September 16, 2021

**Re: Initial Submission Review – Green Valley Ranch East Site Plan No. 5 - Site Plan Amendment with Adjustment and Replat**  
Application Number: **DA-1662-22**  
Case Number(s): 2019-4022-01; 2021-3043-00

On behalf of Oakwood Homes and Terracina Design, we have reviewed the comments dated August 26, 2021. The following is a response to comments.

**PHASING PLAN**

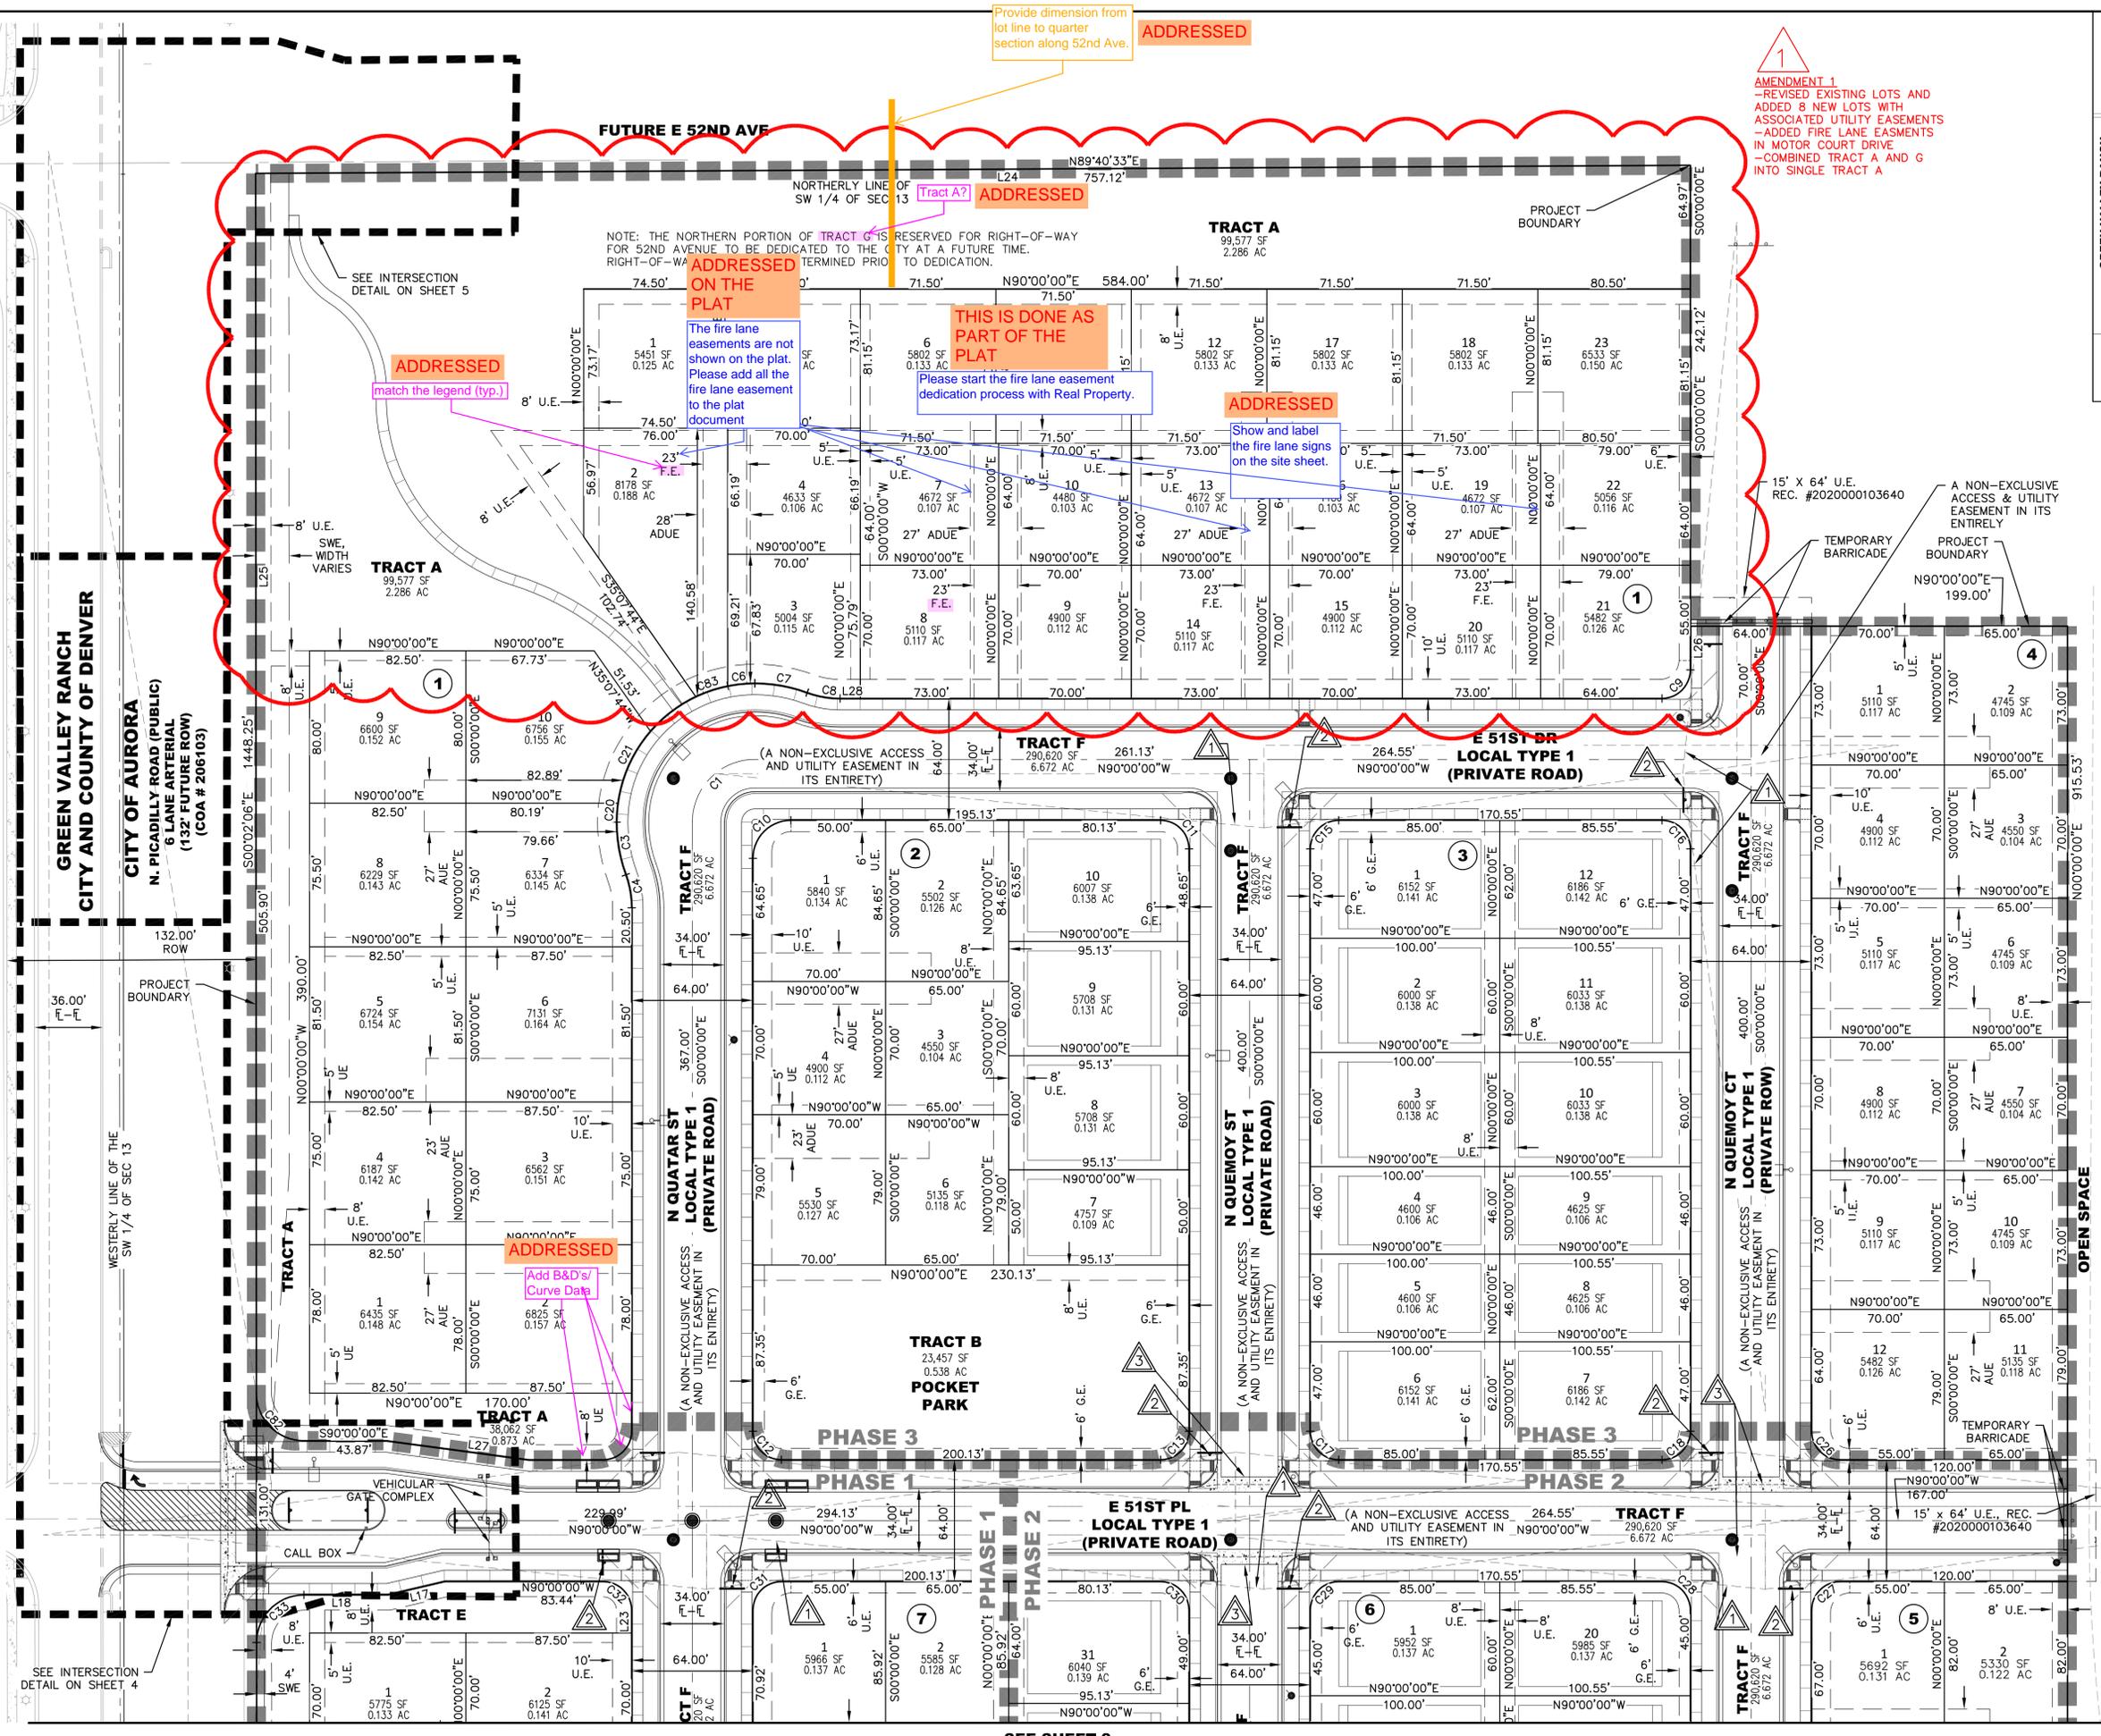
Provide dimension from lot line to quarter section along 52nd Ave.

ADDRESSED

**GREEN VALLEY RANCH EAST PRELIMINARY PLAT #5**  
**OVERALL UTILITY PLAN**

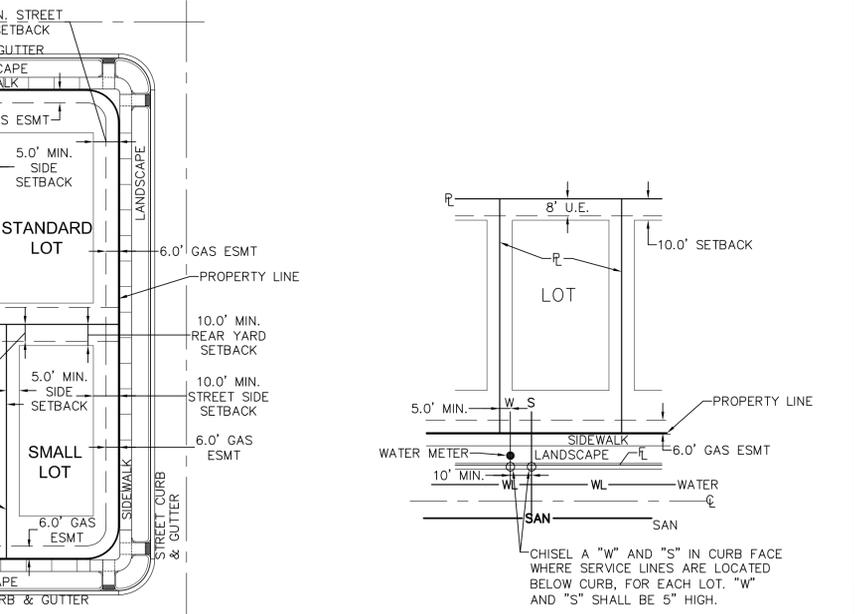
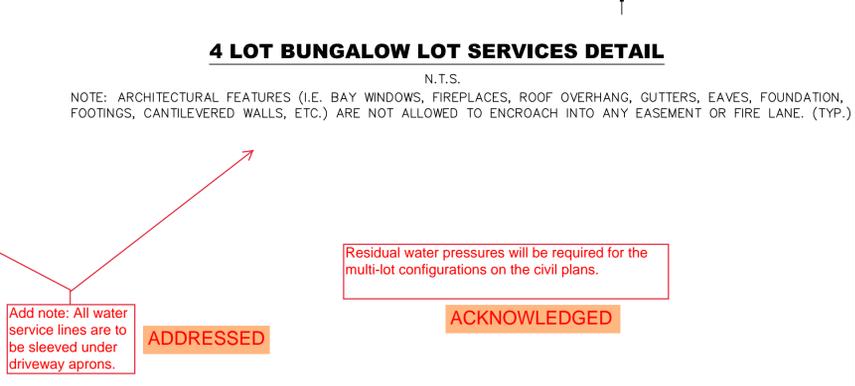
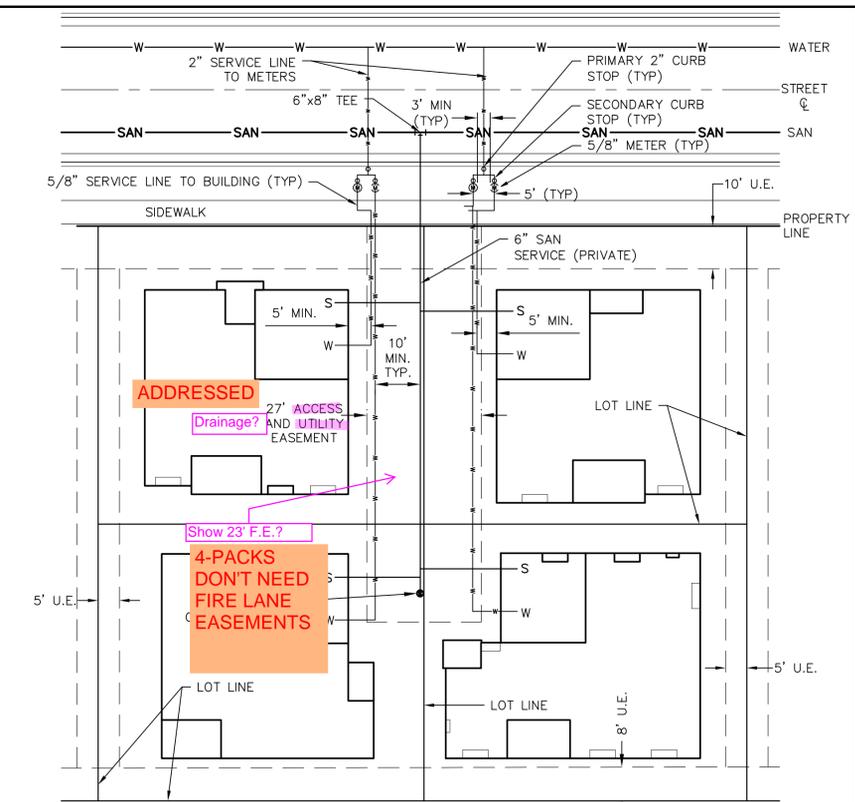
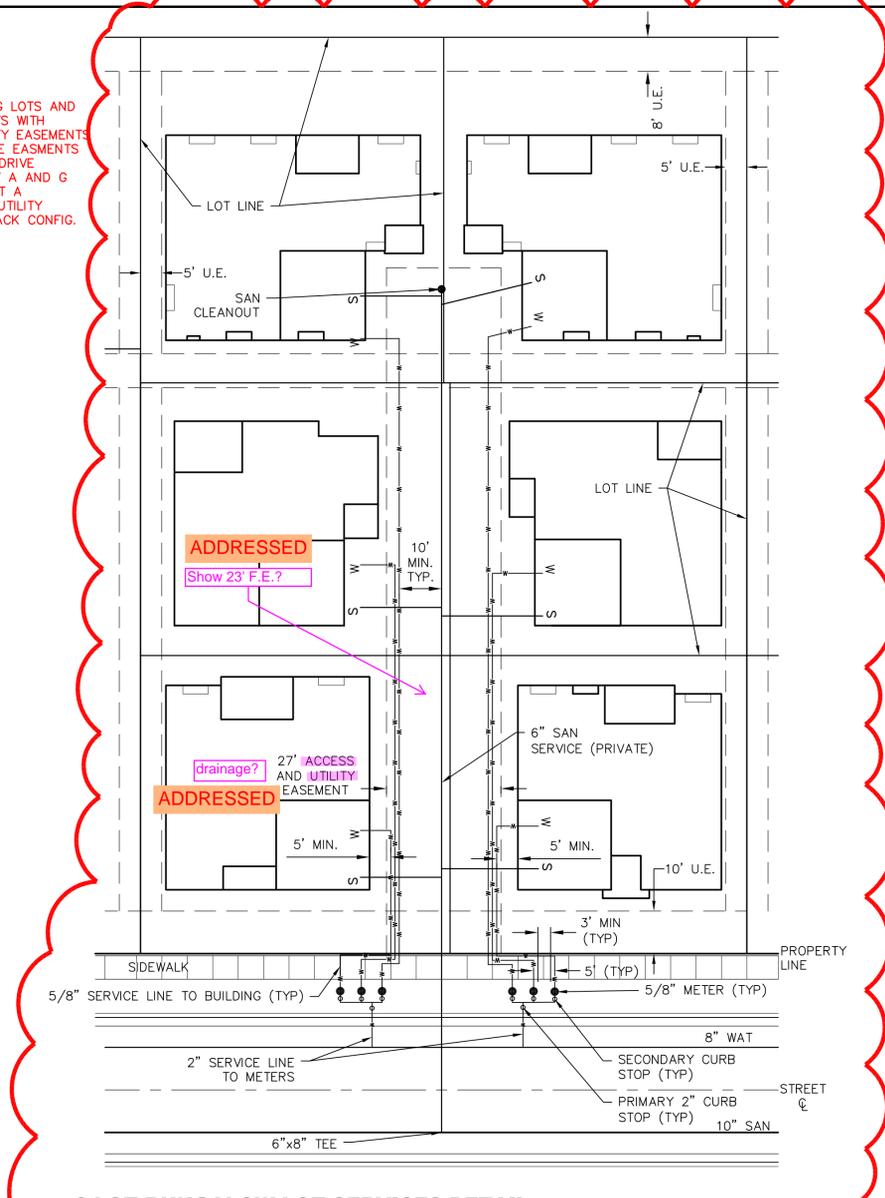
**ADD note: All water service lines are to be sleeved under driveway aprons.**  
**ADDRESSSED**

**Residual water pressures will be required for the multi-lot configurations on the civil plans.**  
**ACKNOWLEDGED**

GREEN VALLEY RANCH EAST  
PRELIMINARY SITE PLAN #5  
TITLE: LANDSCAPE PLAN  
DATE: June 21, 2021

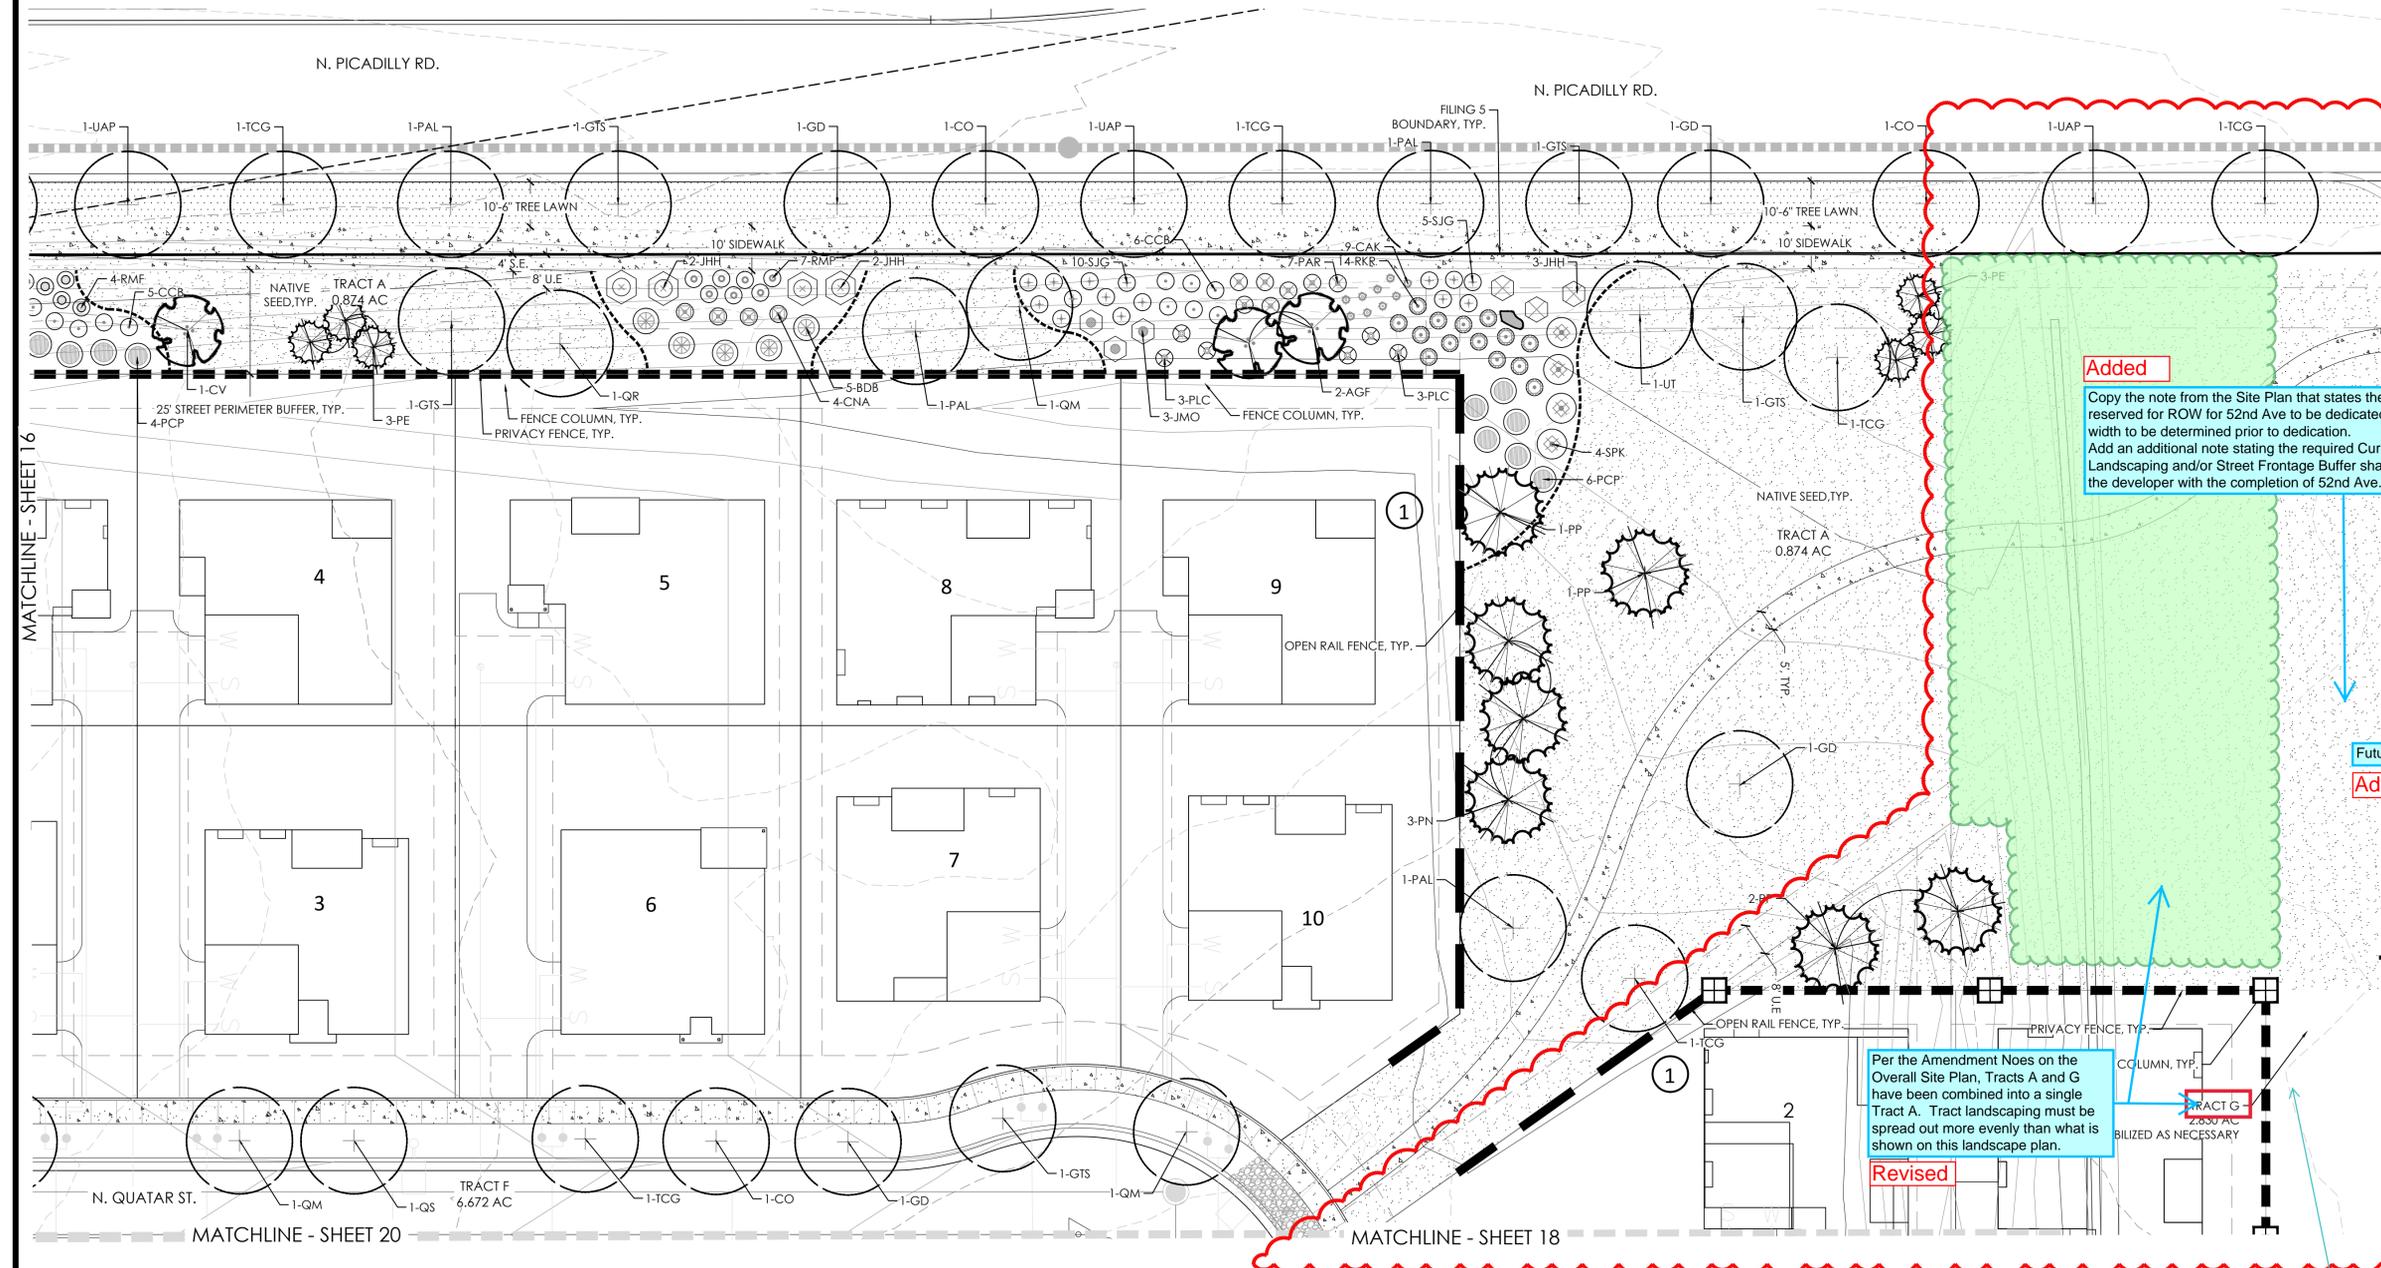
Add a North Arrow to the Key Map on all sheets.  
**Added**

show the general location of the future 52nd Ave ROW and add a note that a buffer no less than 20' will be provided in this tract.  
**Shown**

**Added**  
Copy the note from the Site Plan that states the northern portion of Tract (A) is reserved for ROW for 52nd Ave to be dedicated to the City at a future time. ROW width to be determined prior to dedication.  
Add an additional note stating the required Curbside Landscape, Tract Landscaping and/or Street Frontage Buffer shall be installed and maintained by the developer with the completion of 52nd Ave.

Per the Amendment Noes on the Overall Site Plan, Tracts A and G have been combined into a single Tract A. Tract landscaping must be spread out more evenly than what is shown on this landscape plan.  
**Revised**

**Revised**  
Fix North Arrow Direction
